**Development Permit Panel
Electronic Meeting**

1. DEVELOPMENT PERMIT 23-031345

PROPERTY LOCATION: 12399 Steveston Highway

That a Development Permit be issued which would permit the construction of a two-storey commercial building at 12399 Steveston Highway on a site zoned "Commercial Mixed Use (ZMU18) – The Gardens (Shellmont)".

DP 23-031345
June 5, 2025
Plan #9

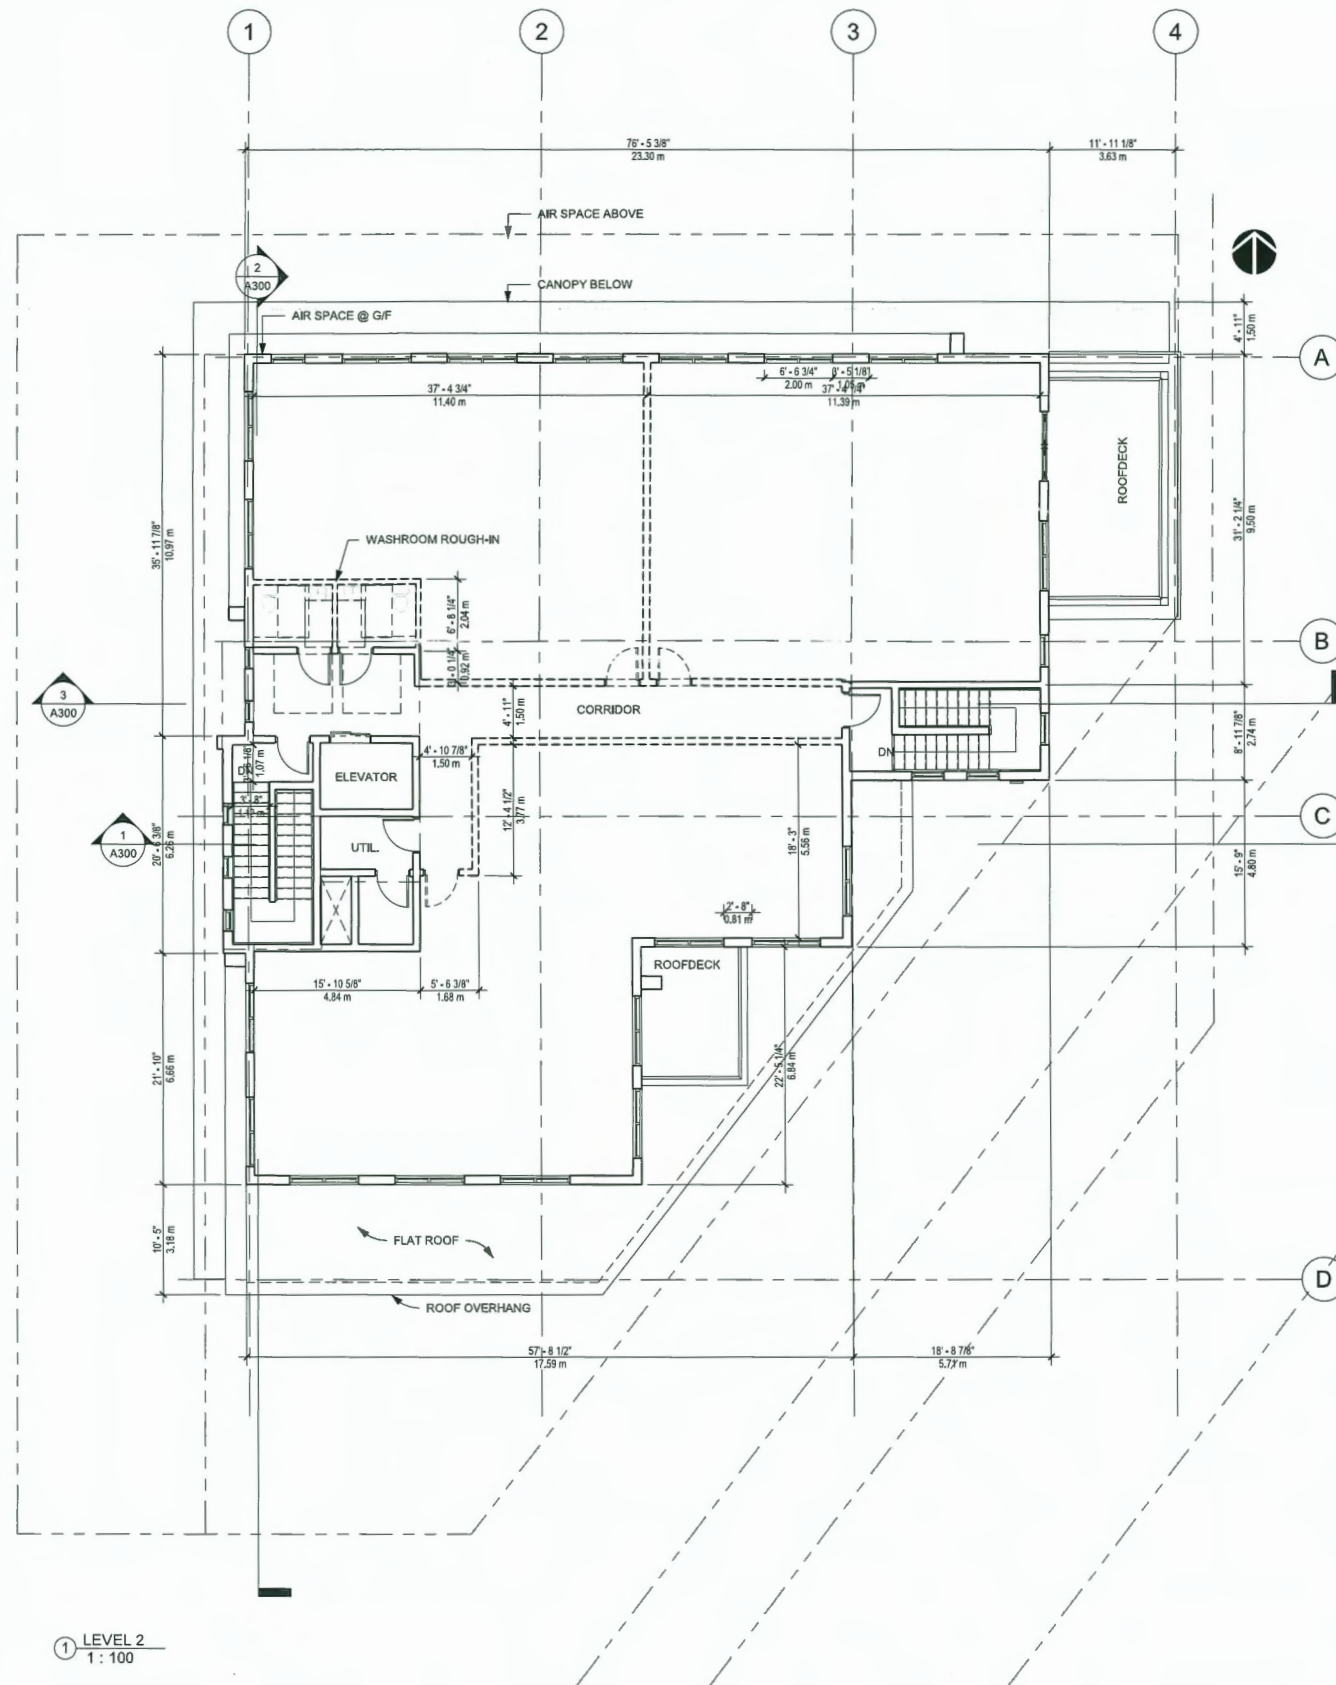
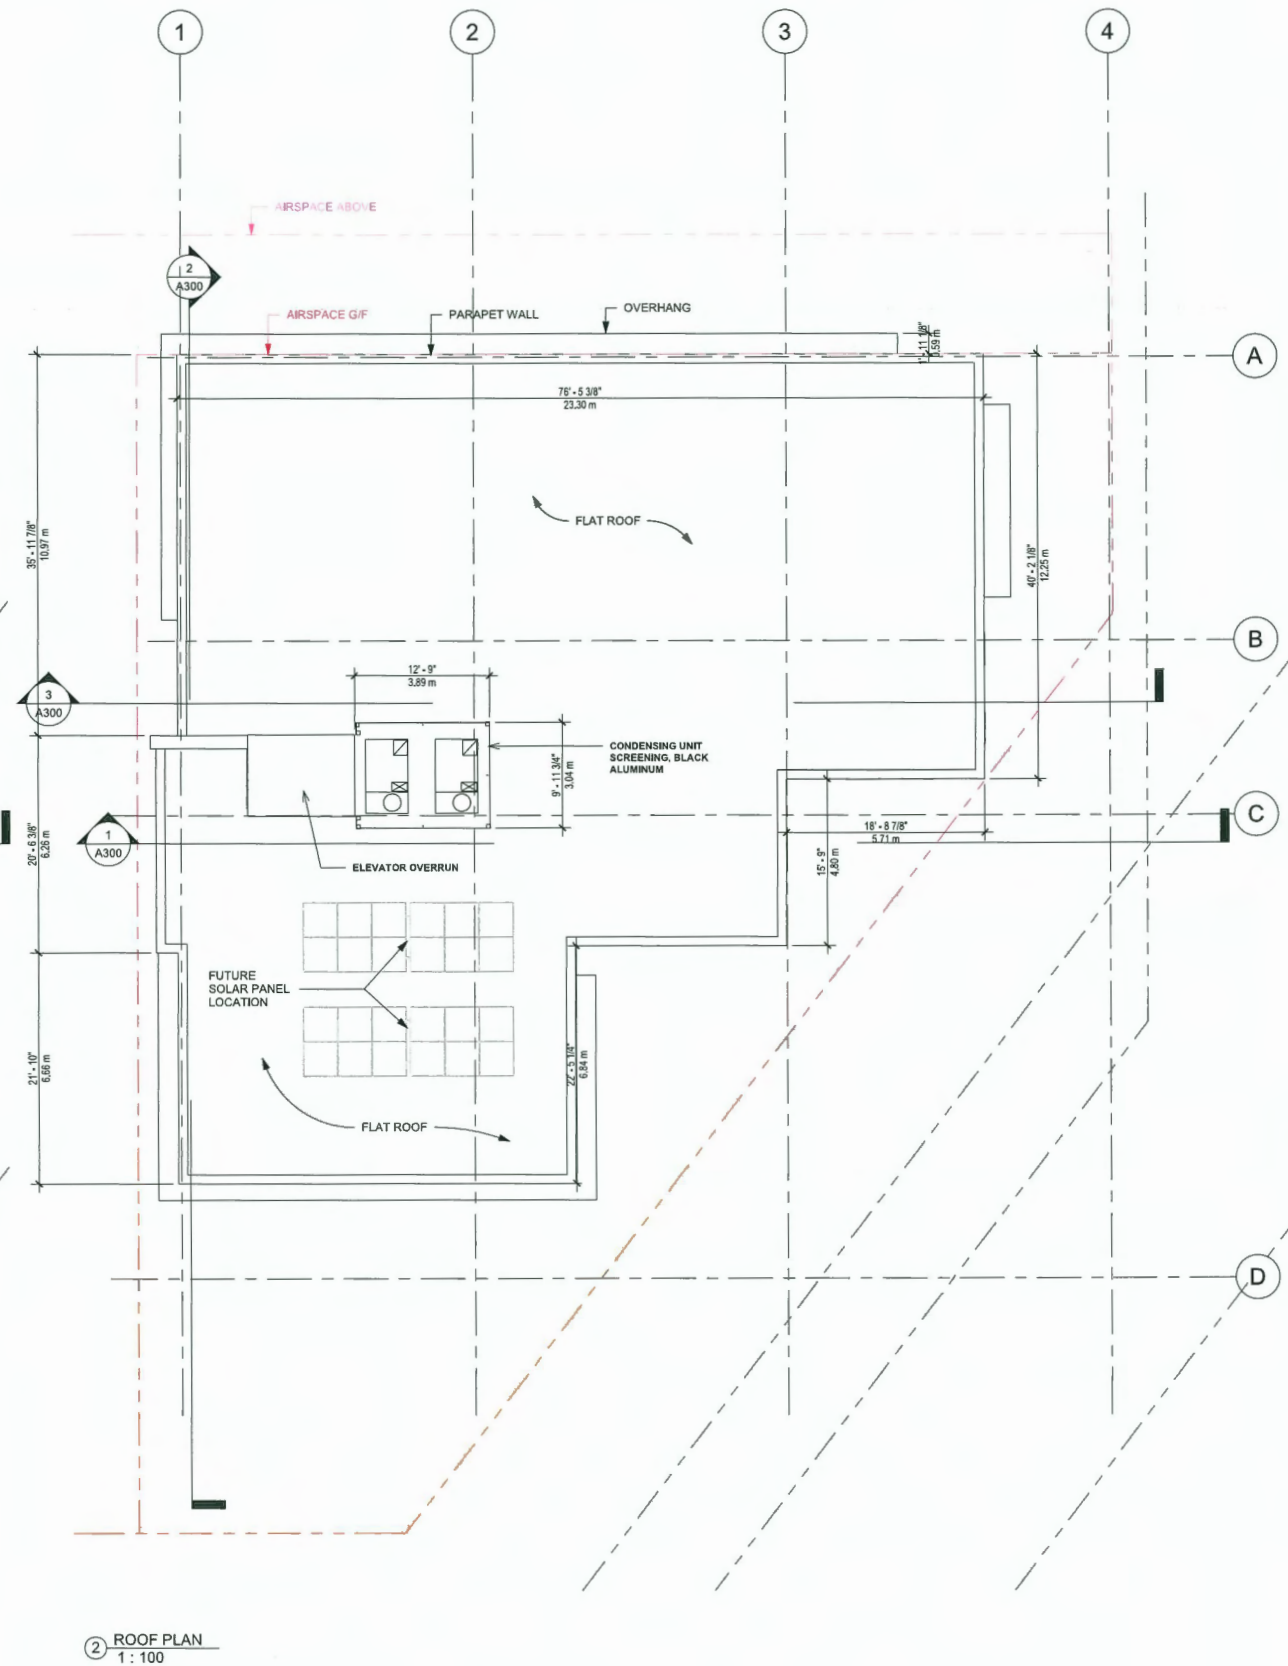
- understand the concerns of installing a green roof on a wood frame building; consider instead installing solar panels on the roof; *We will provide a rough in for future solar connection, please refer to the Architectural Drawings sheet A101 (Plan #9).*

- consider further development to the design of the roof, e.g. installing solar panels, as it is visible from adjacent taller buildings; *We have added a rough in for future panel connection, please refer to sheet A101 (Plan #9) of the Architectural Drawings.*

DP 23-031345
June 5, 2025
Plan #14

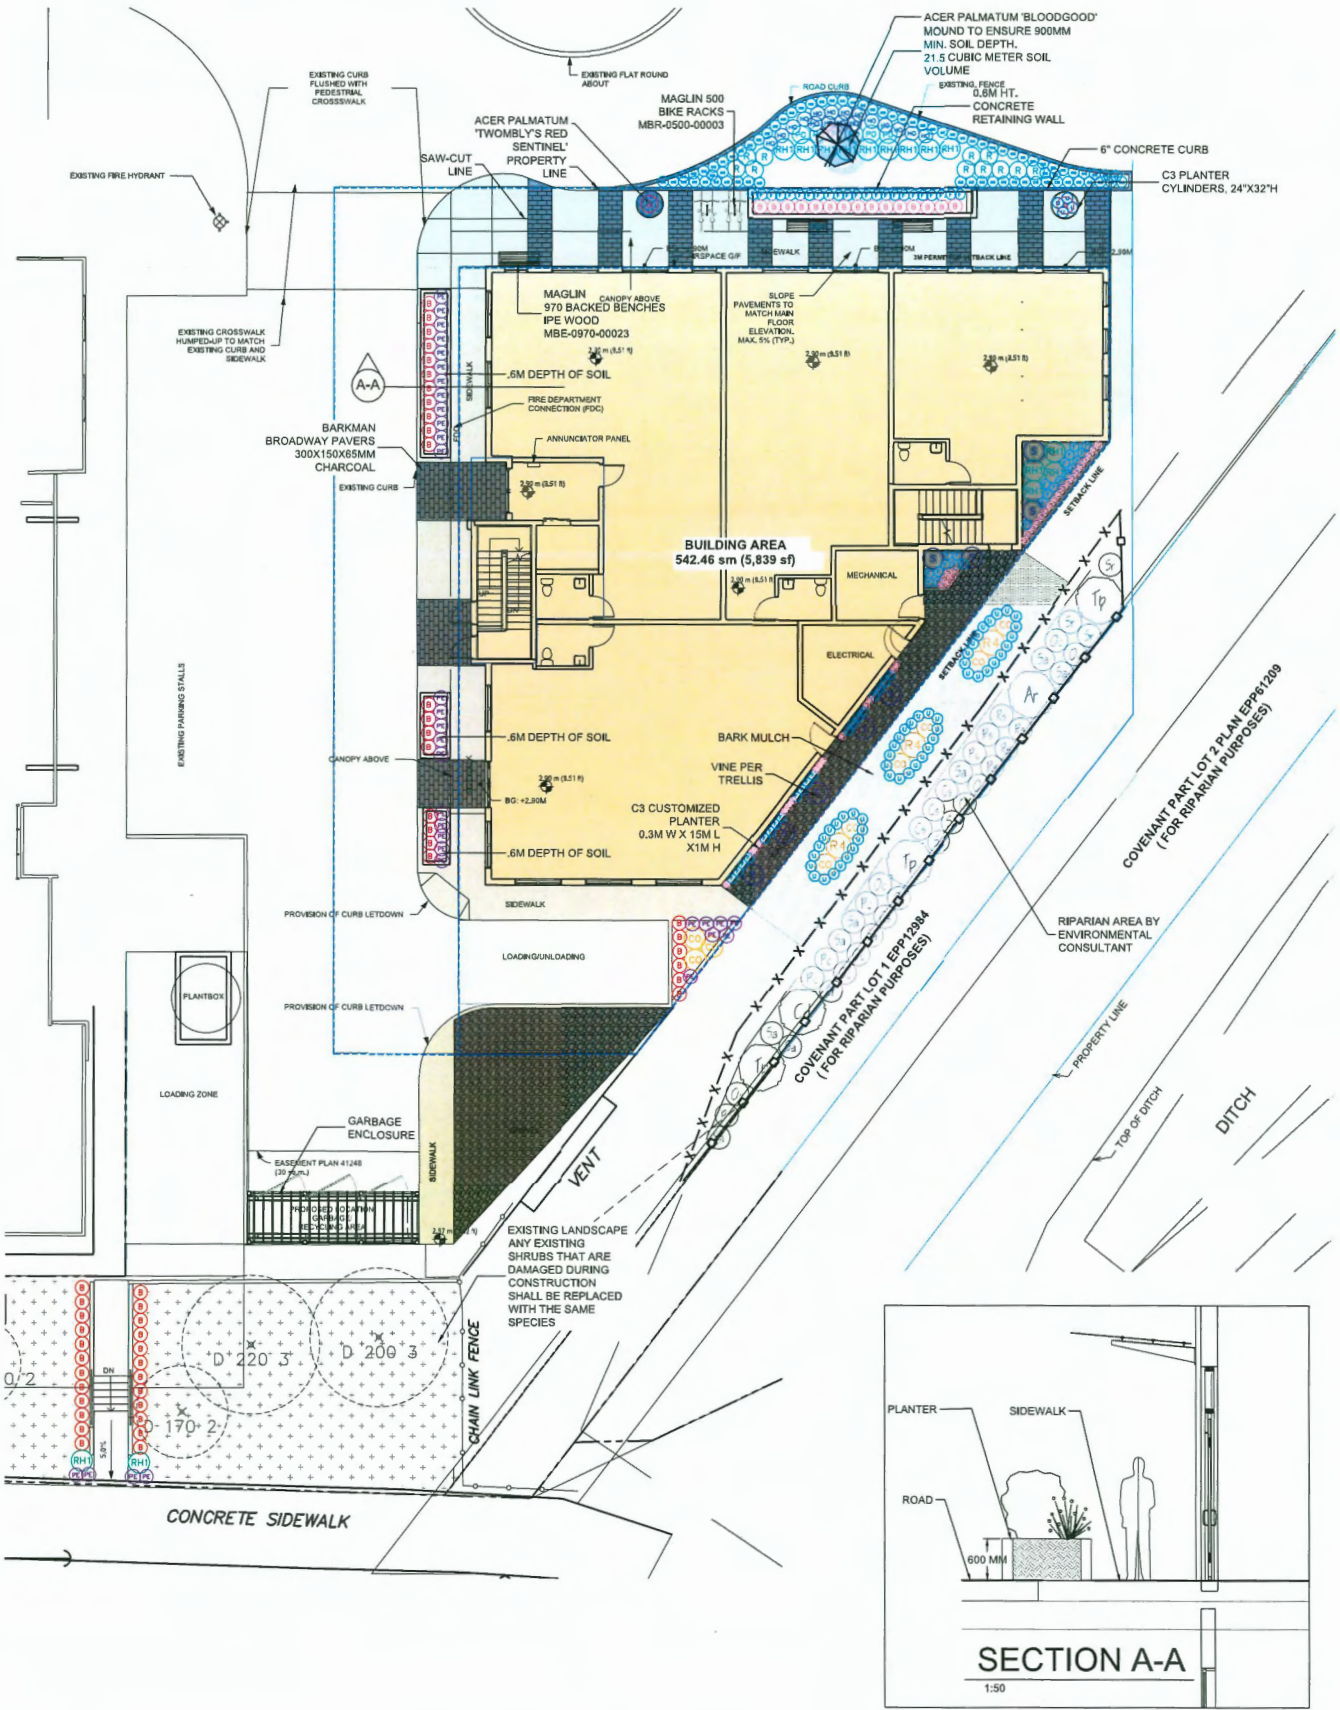
- consider additional planting along the Riparian Management Area to the east of the proposed development to provide more buffer along Highway 99; *We have planted the maximum allowable area in the RMA, please refer to page L2 (Plan #14) on the Landscape drawings for reference. We have also proactively added bearberry evergreen shrubs, perennial rose shrub and red twig dogwood along the Hwy 99 elevation between the RMA and the building to create a more vibrant and inviting elevation.*
